June 20, 2012

RE: L.G. Everist, Inc.
Fort Lupton Sand and Gravel, Permit # M-1999-120
Adequacy Response #1

On behalf of our client L.G. Everist, Inc., I will respond to your May 30, 2012 adequacy review letter as needed in the order and number format presented in that document.

Map Exhibit C-2 -Structures Map

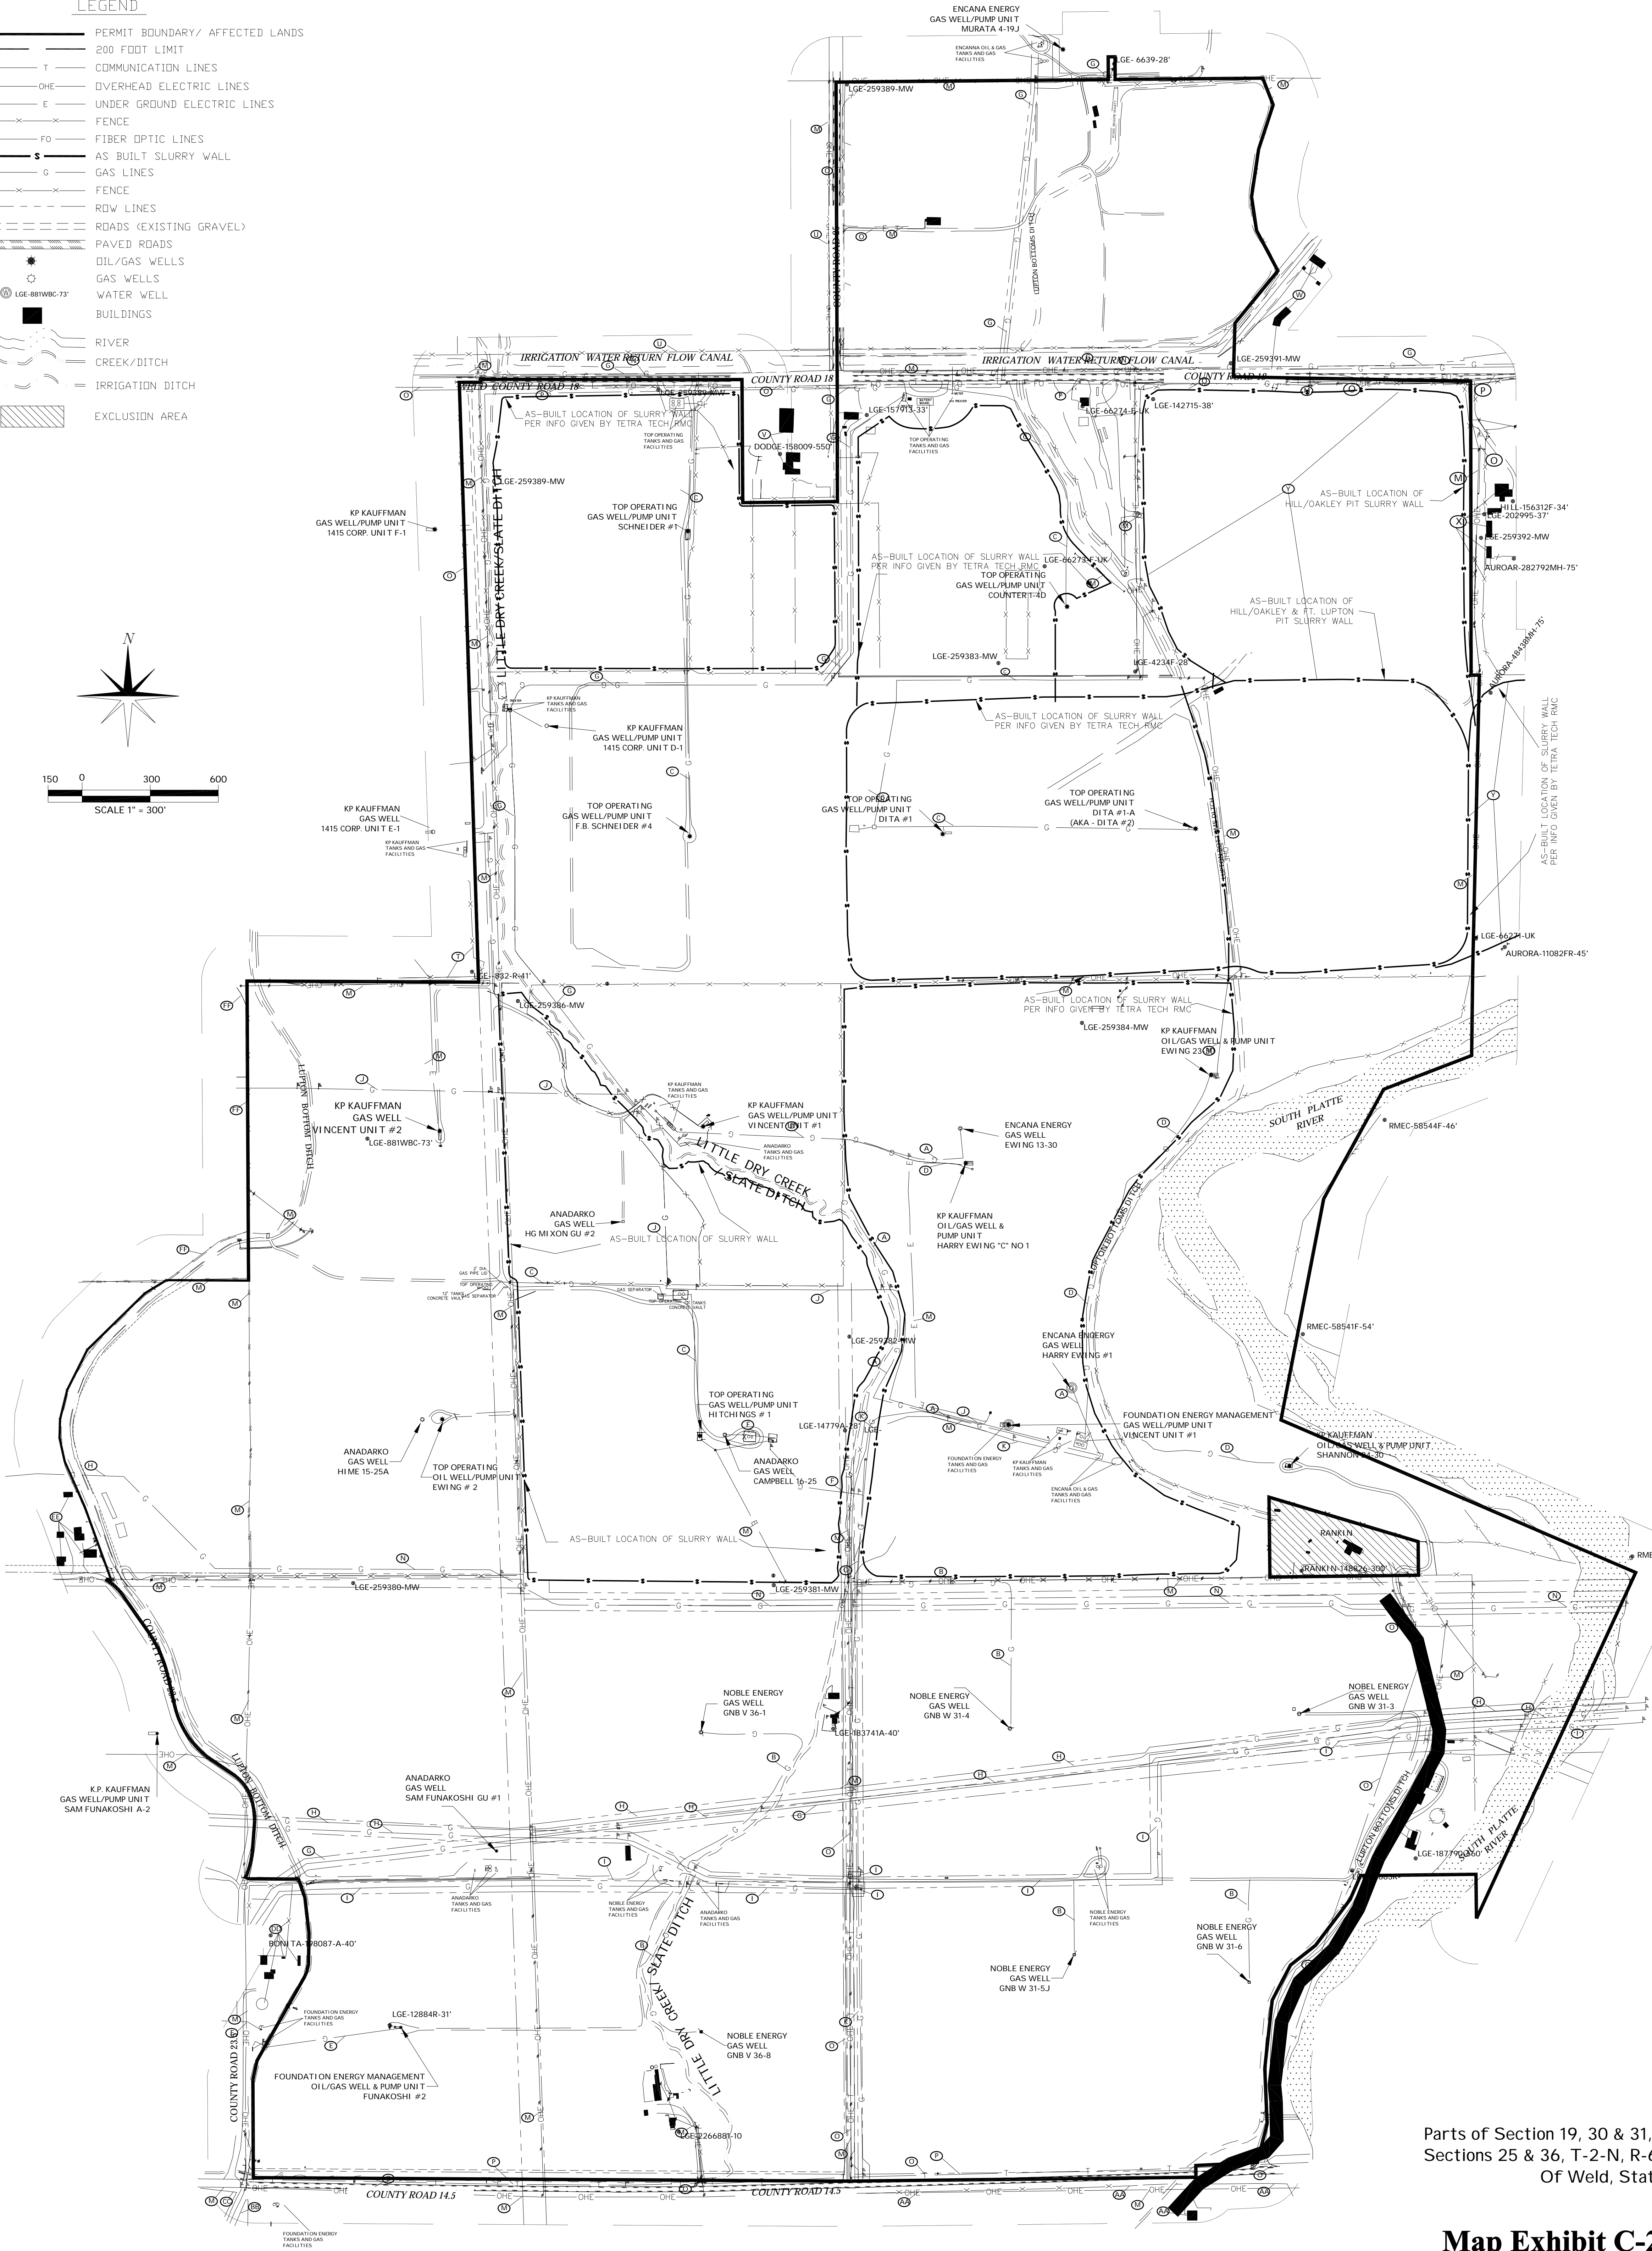
(b) the name and location of all creeks, roads, buildings, oil and gas wells and lines, and power and communication lines on the area of affected land and within two hundred (200) feet of all boundaries of such area; While the overall quality of the maps submitted is very good, they contain so much information as to be a bit difficult to read - especially in black and white. Please present the Structure/ROW information on a separate map that correlates with the Structure/Utility and ROW information included in Exhibit - S.

The third map exhibit in the C-map series is titled **MAP EXHIBIT C-2 STRUCTURES**. The Affected Land/Permit boundary line, roads and water features have been left on the map for reference. I re-scaled the map in the hopes it will be easier to read. Each structure owner was given an alpha label to save map space and then the alpha label was attached to the structure on the map where appropriate.

Fort Lupton Sand and Gravel
 Typical Monitoring Well
 Installation

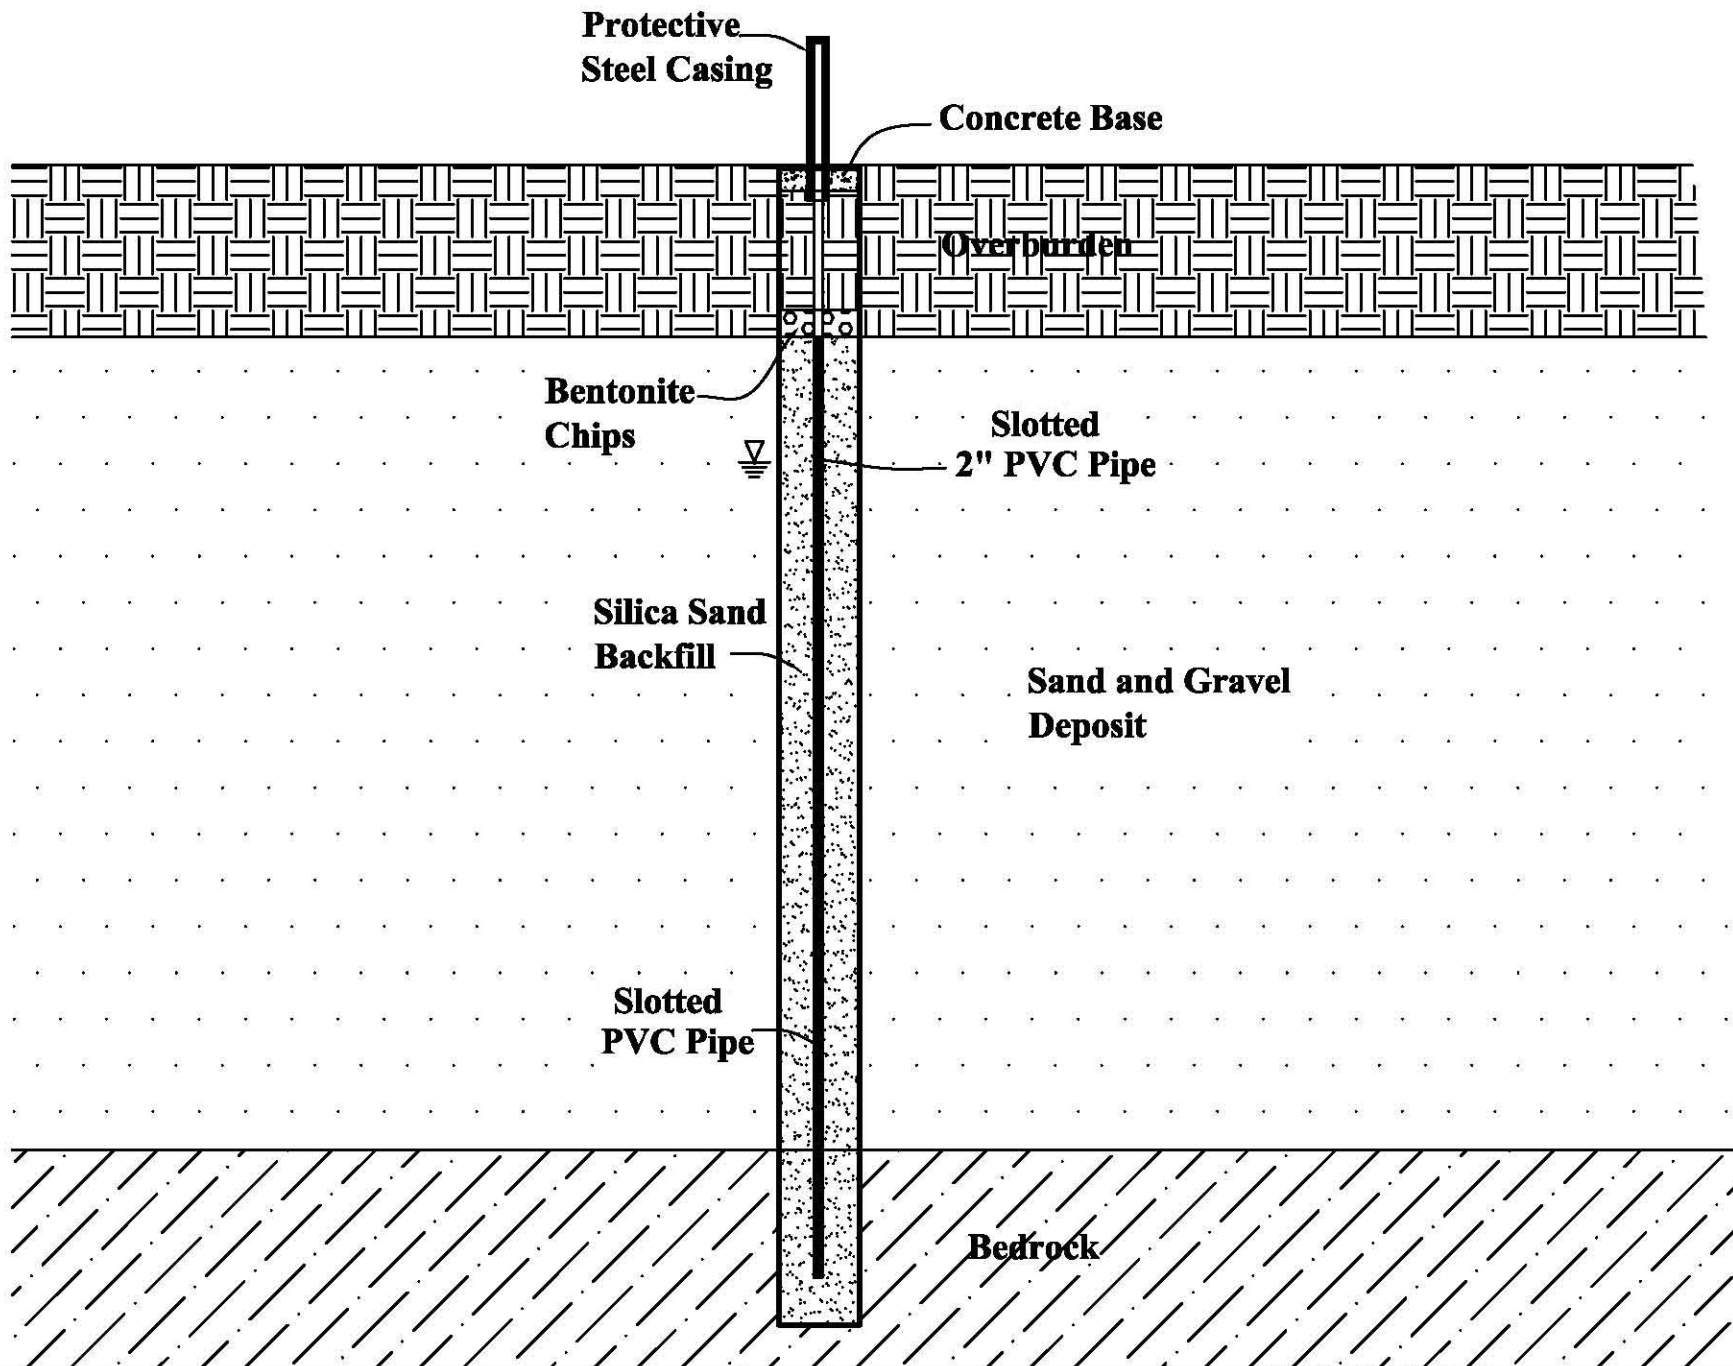
DRMS agrees that groundwater issues are often complex interactions between a variety of factors; however, deviations from standard DRMS practice (such as the 2-foot trigger levels) must be based on defensible groundwater monitoring data and not speculation and/or circumstantial factors. The narrative provided also refers to wells such as "monitoring wells 9 and 10" but Figure G-2 does not identify any wells with these names. Please provide an updated Figure G-2 that

depicts all existing and proposed monitoring well locations for this site with identifiers that correspond to the data collected from them. Well construction diagrams and a summary of historical data should also be provided for existing monitoring wells. When are the new monitoring wells going to be installed?

Attached is a revised Figure G-2 which shows the location of all the piezometers in use at the mine and a sketch of the typical construction diagram for the wells as installed. The aerial photo date for the G-2 map is June 2010.

Geotechnical Stability Exhibit

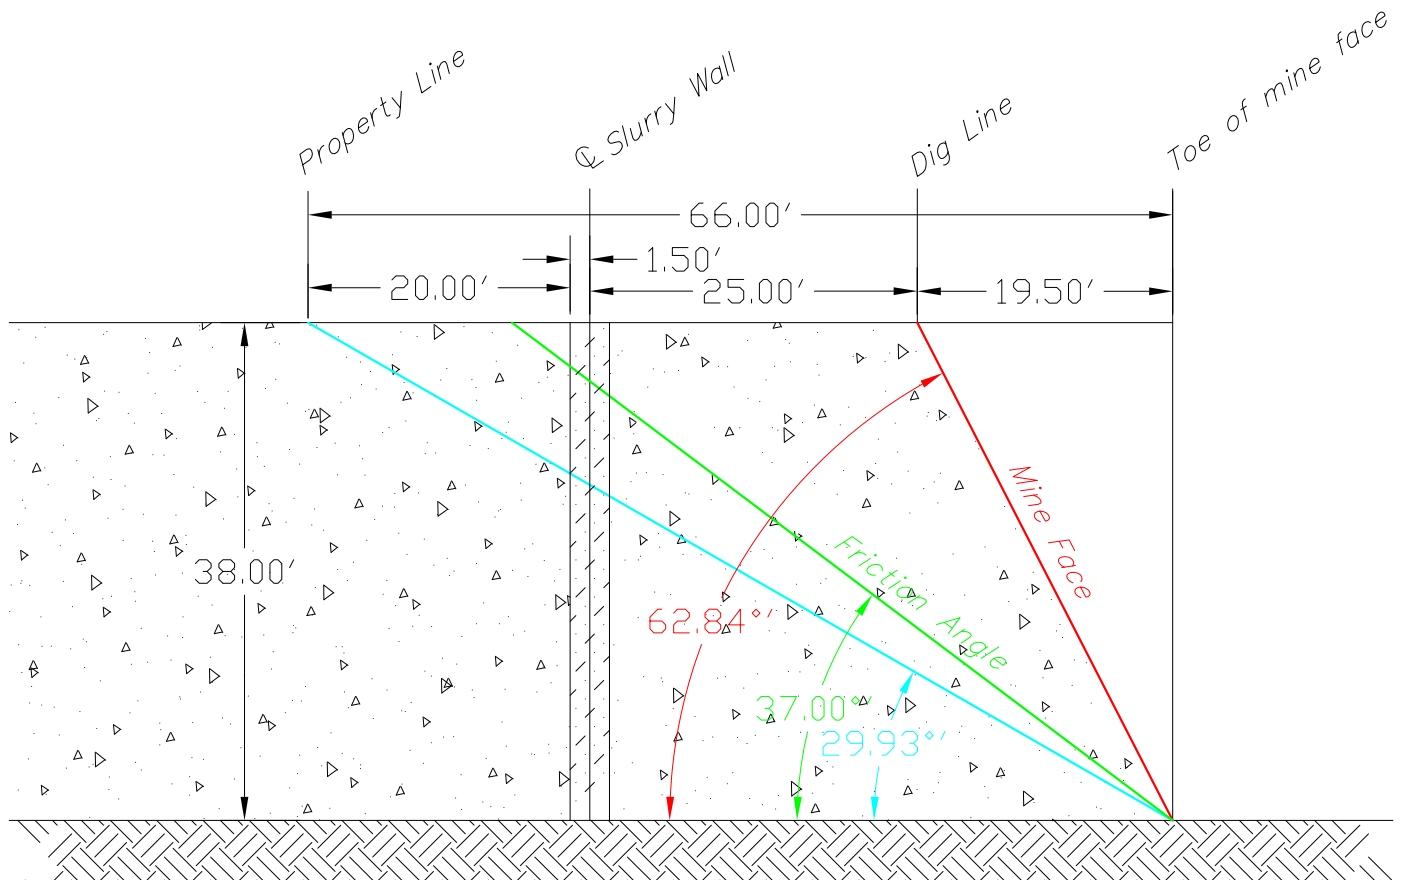
DRMS acknowledges that all surrounding structure owners have been notified and provided with a damage waiver agreement – with the exception of Welco Ventures whose notification appears to have been returned as undeliverable. As required by Rule 6.4.19, Please provide sufficient information to demonstrate that the stability of any structures located within two hundred (200) feet

of the affected land will not be adversely affected for structures for which signed agreements have not been received at this time.

A slope stability analysis was prepared by Tetra Tech on 8/31/04 based on mining the slope from 1.3:1 to 1.5:1 and the Division suggested there could be communication problems between the permit and the actual practices by the mine personal. To avoid this we changed the mining method so the mining face slope will be mined at a rate of near vertical to ½:1 slope and changed the fixed setback from the property line or structure to allow for installation of slurry walls. The setback from the permit/affected lands line to the outer edge of the slurry wall is a minimum of 20 feet; the slurry wall is 3 feet wide and the mining setback is 25 feet from the center of the slurry wall to the dig line. This will leave a 46.5 foot setback from the property line to the dig line. Please review the attached sketch plat which shows the related slopes and depths discussed in this text.

In Mr. Sorenson's adequacy response letter dated 12/31/2004, he responded to the Tetra Tech letter and suggested using a friction angle of 35° (1.43:1) was more appropriate for calculating the safety factor. In lieu of redoing the report L.G. Everist choose to obtain structure agreements from the structure owners around the 2004 amendment area. In the new area we have structures where waivers have not been obtained yet. So in lieu of that we have prepared a slope stability analysis using Mr. Sorenson's suggested friction angle factor. This analysis uses a worst case scenario so that if the setback is adequate to protect the structure in that case, then it will be adequate for structures farther away. In this case the closest structure is the fence along the north side of the Vincent West Stage and the Sandstead property on the west side of the mine. The deepest point from surface to shale is 38 feet is used in the calculations. Please review the attached **Geotechnical Stability Exhibit** for details.

In conclusion, the analysis shows that the 46 foot setback is more than adequate to protect any structures not owned by L.G. Everist within 200 feet of the permit line having a safety factor of 1.22. This safety factor along with the plan to begin backfilling against the mining face as mining progresses will eliminate the likelihood that a slope failure would occur that might impact any structure.
